# UNITED STATES PATENT AND TRADEMARK OFFICE

APPLICATION NO.	FILING DATE	FIRST NAMED INVENTOR	ATTORNEY DOCKET NO.	CONFIRMATION NO.
10/006,635	11/08/2001	Sam S. Vacek	VAC-1001-US	1869

Inventor: Vacek  
 Title: System and Method For Inhibiting Moisture...  
 Serial No.: 10/006,635; Filed: November 8, 2001  
 Confirmation No.: 1869; Docket No.: VAC-1001-US  
**REPLACEMENT SHEET**

FIG 2B

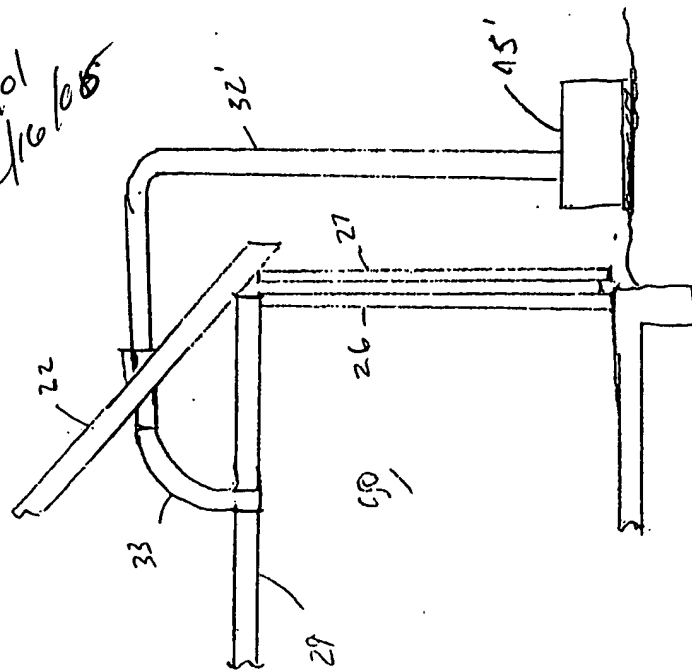
3. The disclosure is objected to because of the following informalities: there is no brief description of figures 2A and 2B, there are several references to figure 2 which no longer exists as it has been replaced by figures 2A and 2B, and reference numerals 32' and 45' shown in figure 2B are not found in the specification.

FIG 2

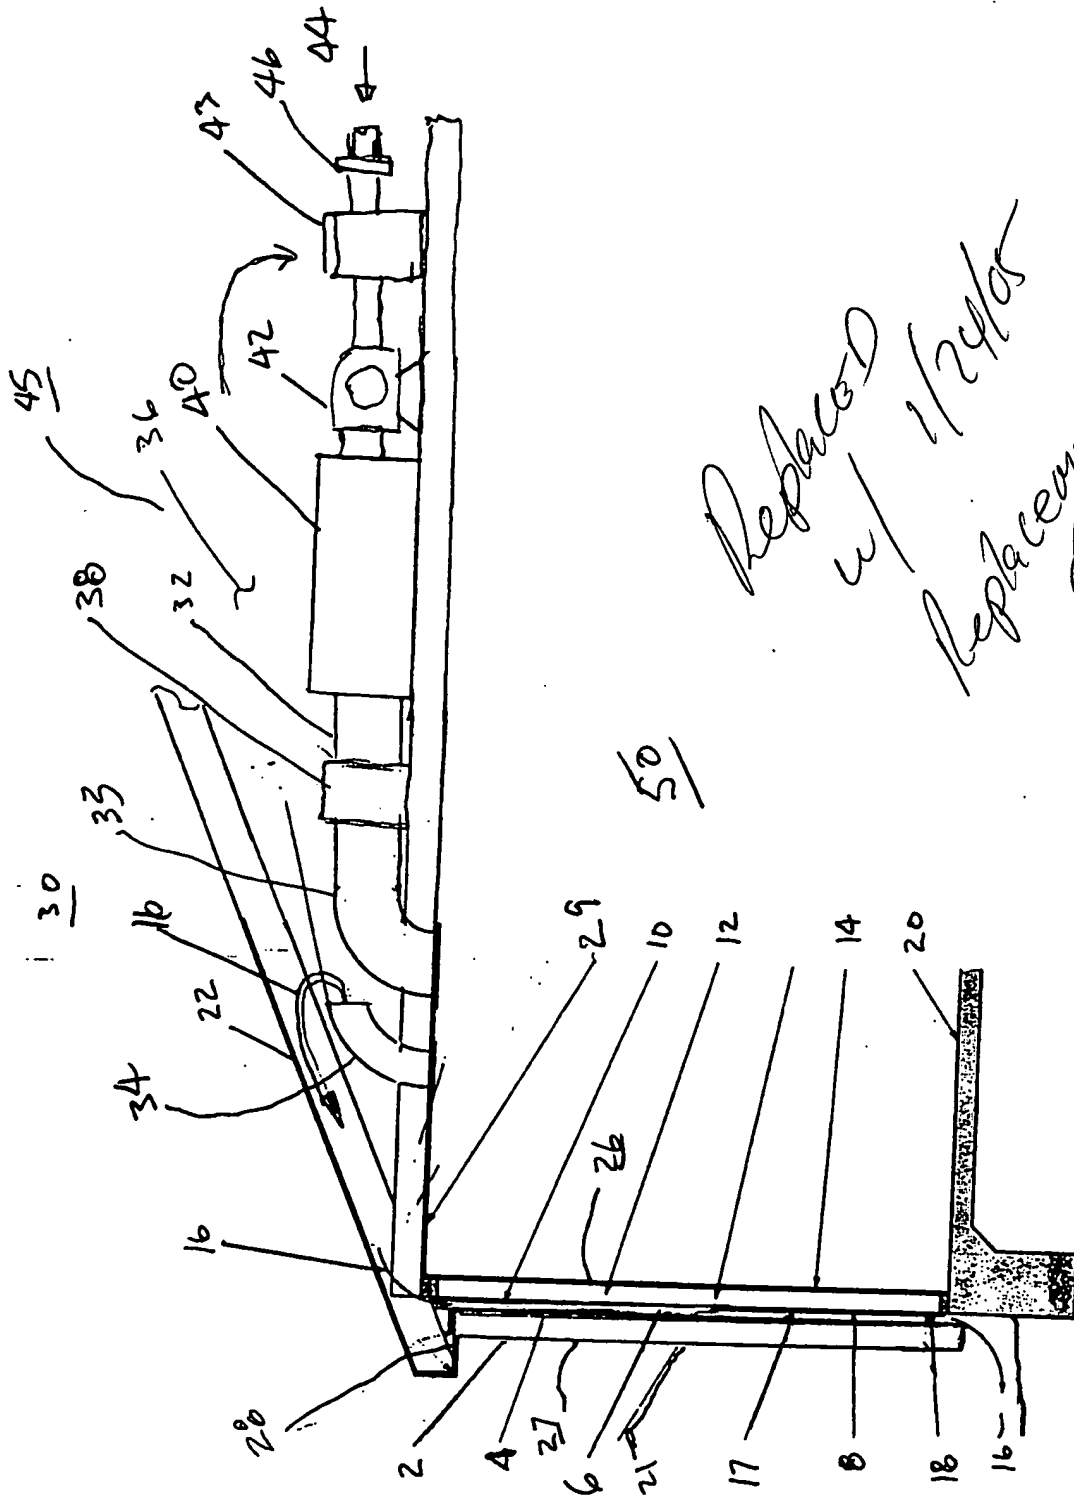
Replaced  
w/ 1/24/05  
Replacement  
Sheet
